*Mountain Chute G2 Excitation System Replacement
Notification of Approval of Connection Proposal
CAA ID Number: 2009-EX433*

**Project: Excitation System Replacement for
Mountain Chute G2**

CAA ID: 2009-EX433

MOUNTAIN CHUTE G2 – EXCITATION SYSTEM REPLACEMENT IESO EXPEDITED SYSTEM IMPACT ASSESSMENT – 2009-EX433

Figure 1: Block Diagram of Excitation System

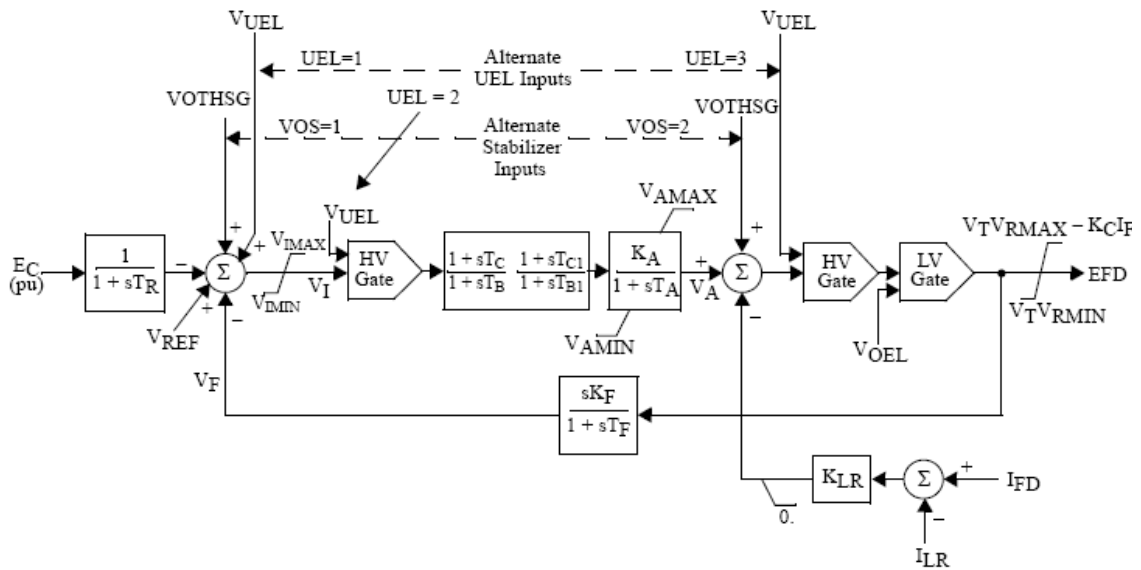
The performance of the proposed exciter has not been verified through testing. After the installation of the proposed exciter, the proponent is required to perform commissioning tests to validate the control model and data. The test results must be supplied to the IESO within three months of the in-service date. If the actual data differs materially from the data that was used in the assessment, then the analysis will need to be repeated.

As soon as the commissioning tests are completed and actual data is available, the connection applicant is required to provide updated block diagram models of the excitation system. Using these data the IESO will perform studies to verify the behaviour of the excitation system and establish the need for any new controls and adjustments, as part of the Market Entry Process.

Figure 2: Block Diagram of PSS

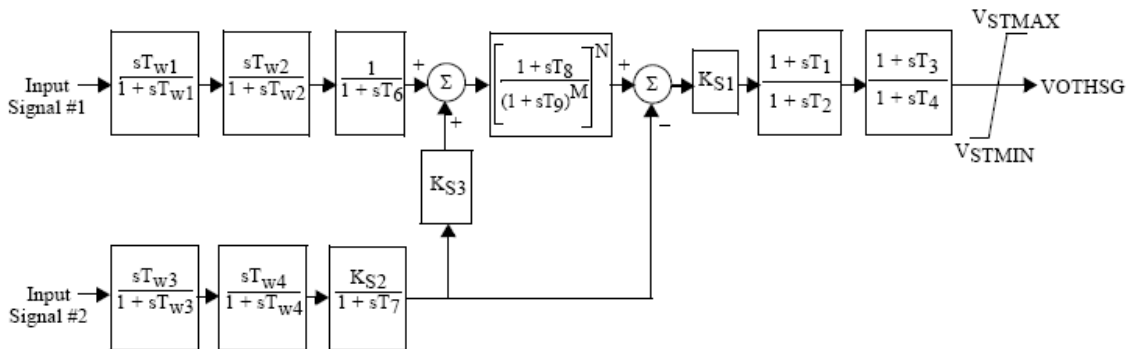
It should be noted that the data in Table 2 are preliminary and the PSS model and data are to be finalized by the connection applicants upon the completion of commissioning test and provided to the IESO in view of completing the Market Entry Process.

Figure 3: Response Ratio Test Results

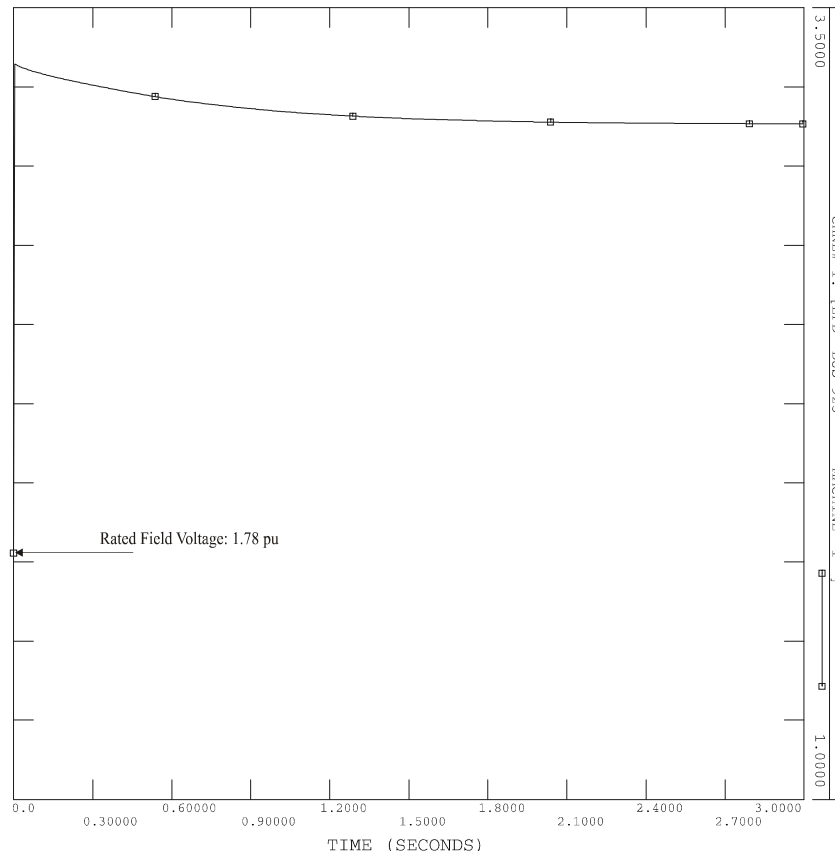
The results of response ratio test shown in Figure 3 indicate that the exciter rated field voltage is 1.78 pu and the response ratio is 3.60.

Therefore, positive ceiling must be at least $2 \times 1.78 = 3.56$ pu for higher requirements or $1.5 \times 1.78 = 2.67$ pu for lower requirements, and negative ceiling must be at least $-1.4 \times 1.78 = -2.49$ pu.

Figure 4: Open Circuit Test Results

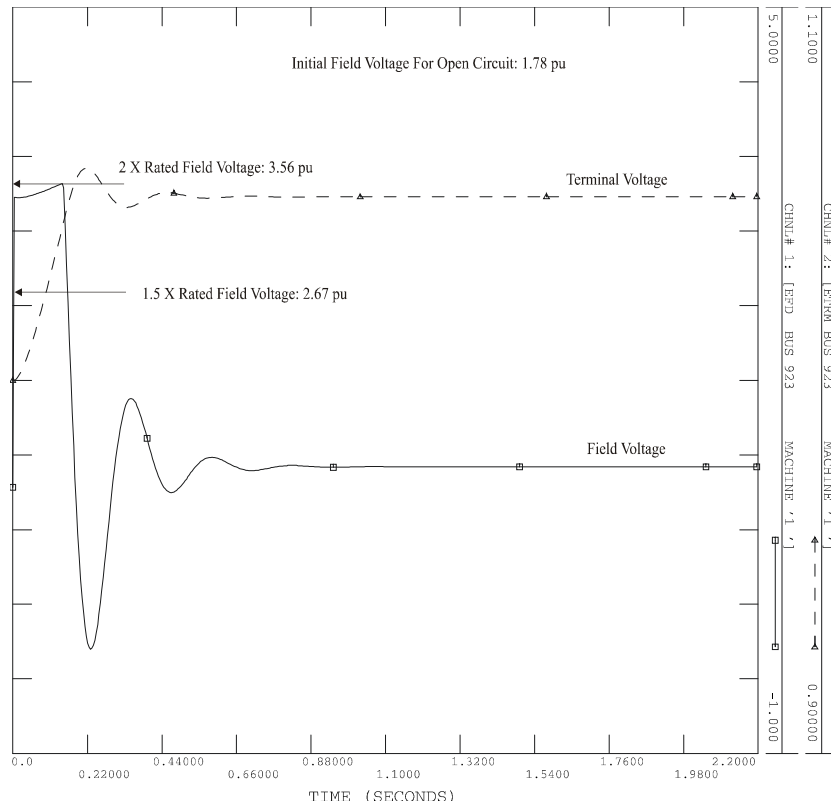
It can be seen that the positive ceiling voltage is 3.15 and meets the above-mentioned lower requirements.

Figure 5: Open Circuit Test Results

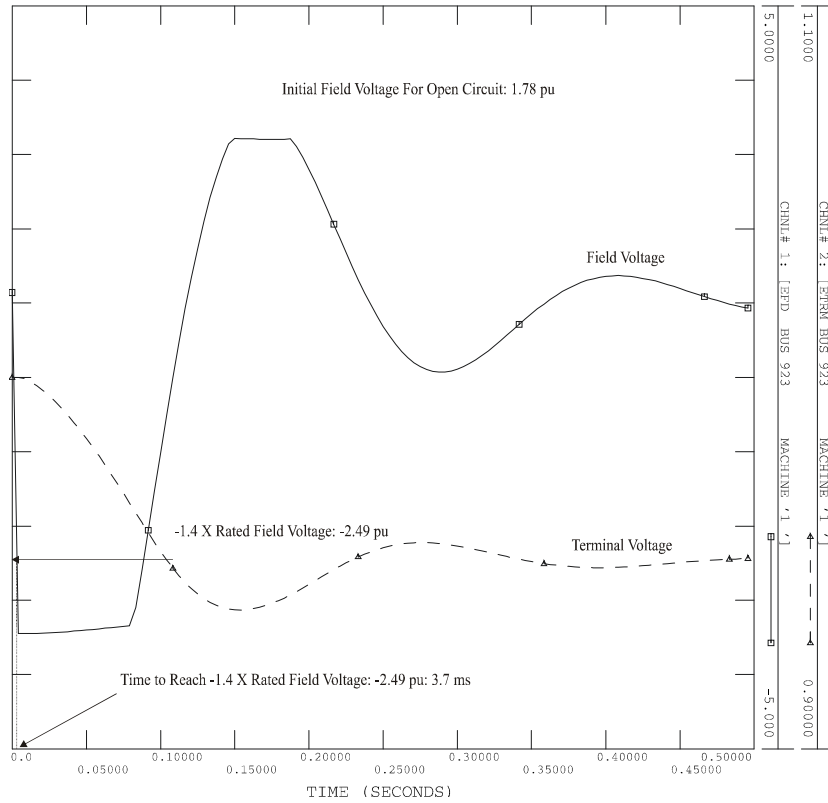
The time to reach $-1.4 E_{fd_{rated}}$ under open circuit conditions will need to be within 42 ms.

Results in Figure 5 show that the field voltage has a negative ceiling voltage of -3.5 pu which is below the required $-1.4 E_{fd_{rated}}$, -2.49 pu. Examination of the plots indicates that the exciter field voltage reaches $-1.4 E_{fd_{rated}}$ in 3.7 ms for the proposed excitation system.

Therefore, it can be concluded that the negative ceiling voltage for the proposed exciter satisfies Market Rules requirements.

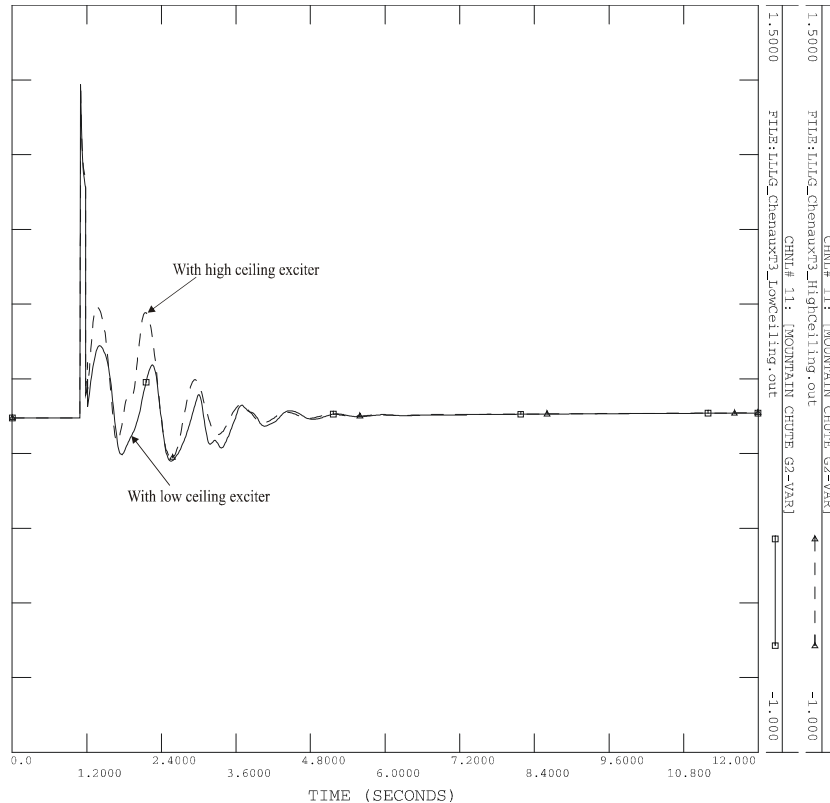
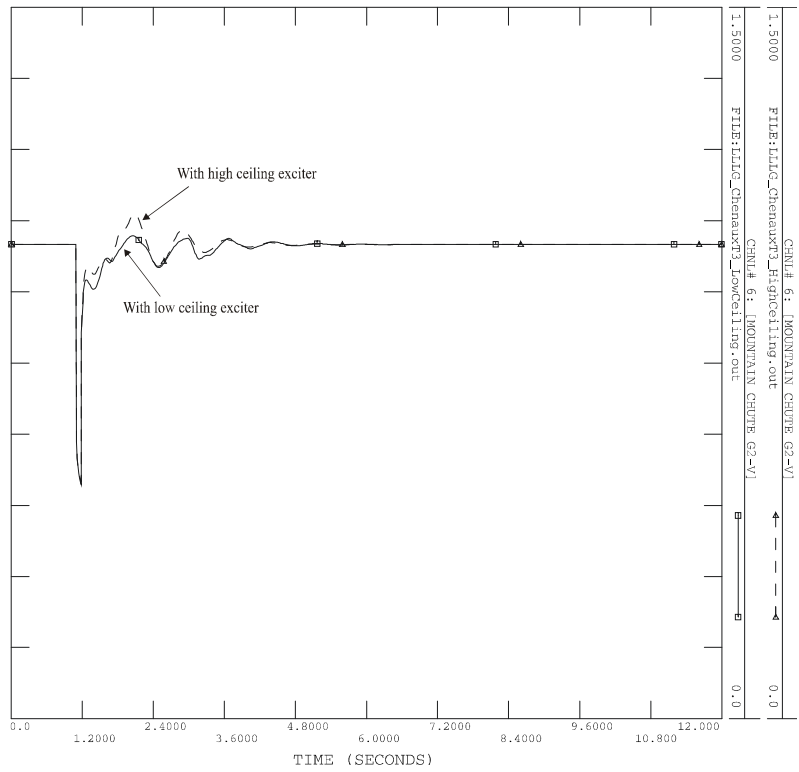
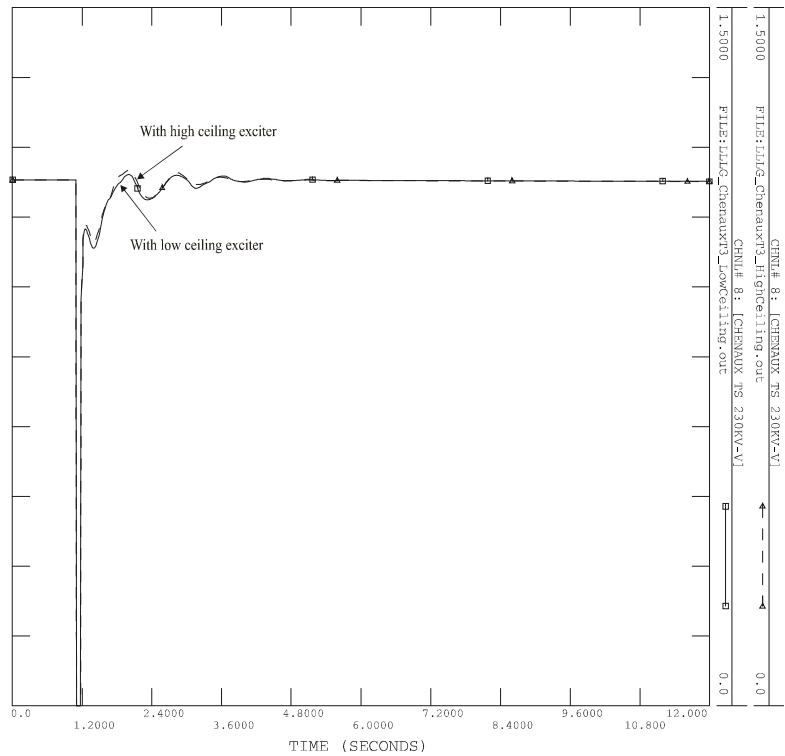
The results show that with a high ceiling exciter G2 at Mountain chute will produce more reactive power during transient and the terminal voltage is a little higher. For the 230 kV voltage at Chenaux TS, the effect of voltage drop resulting from the low ceiling exciter is very slight. Therefore, it can be concluded that the impact of low ceiling exciter is not significant comparing with a high ceiling exciter but it is better to have a high ceiling exciter to contribute more to system stability.

OPG is required to install a new exciter which should meet Market Rules requirements for Mountain Chute G2 during the rewinding outage.

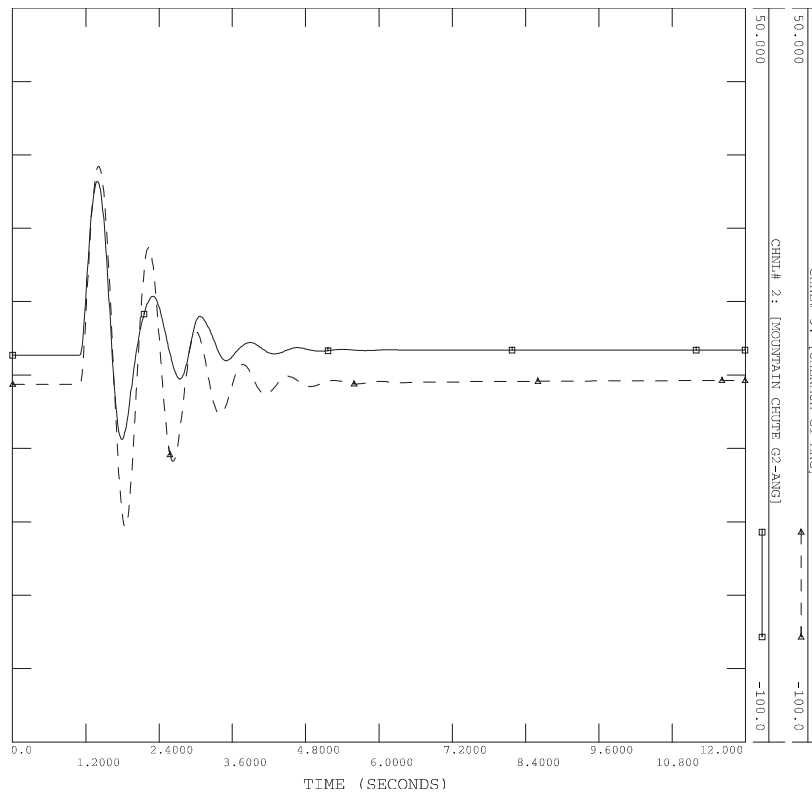
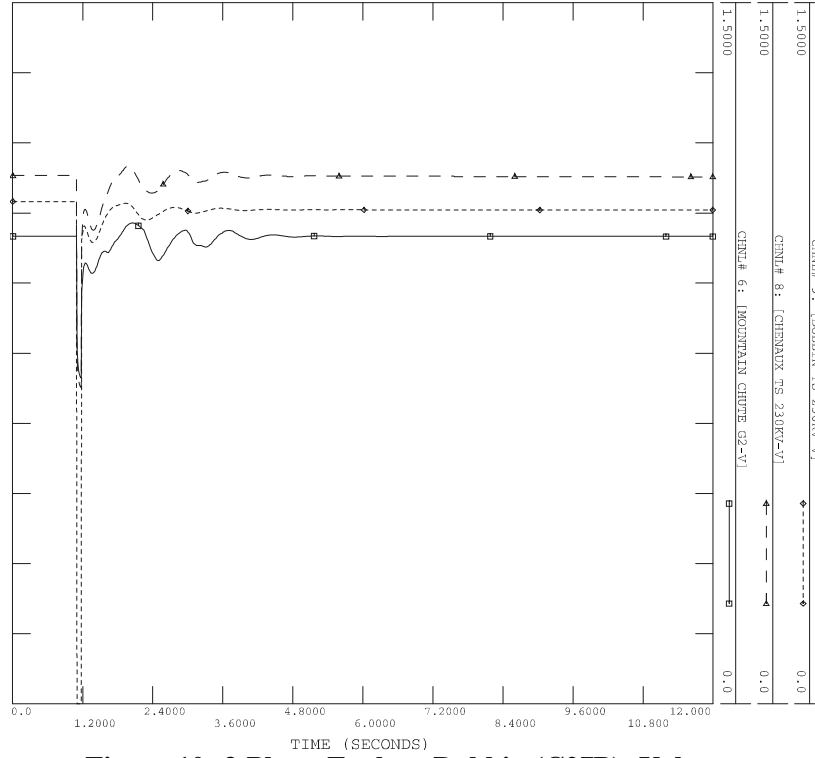
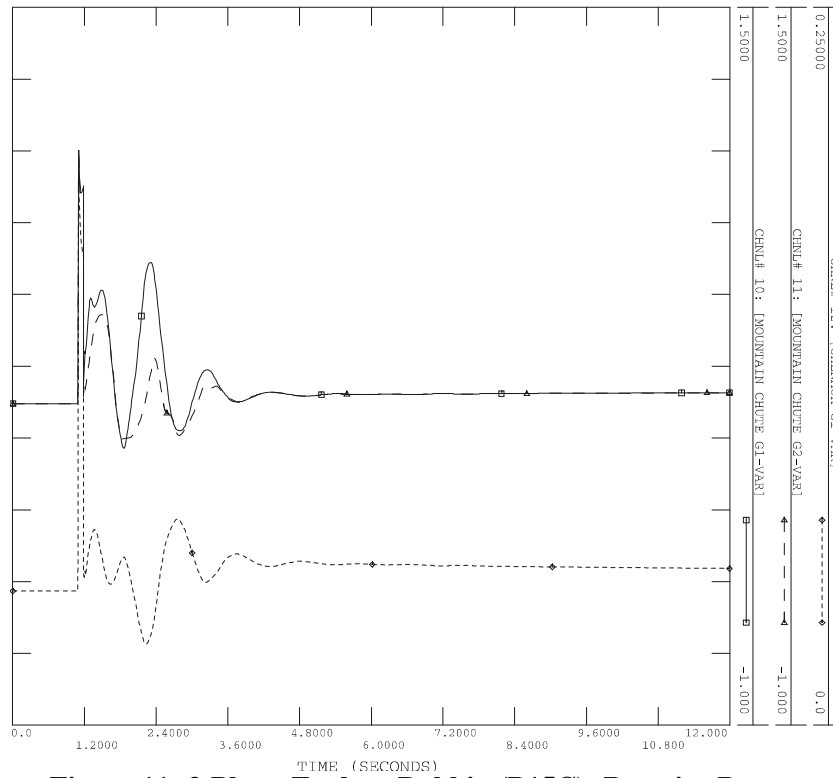
It can be seen that the system displays stable performance and the oscillations are well damped. Therefore, based on the transient stability study results it can be concluded that the proposed replacement of the exciter at Mountain Chute G2 would not adversely impact the reliable operation of the IESO-controlled grid.
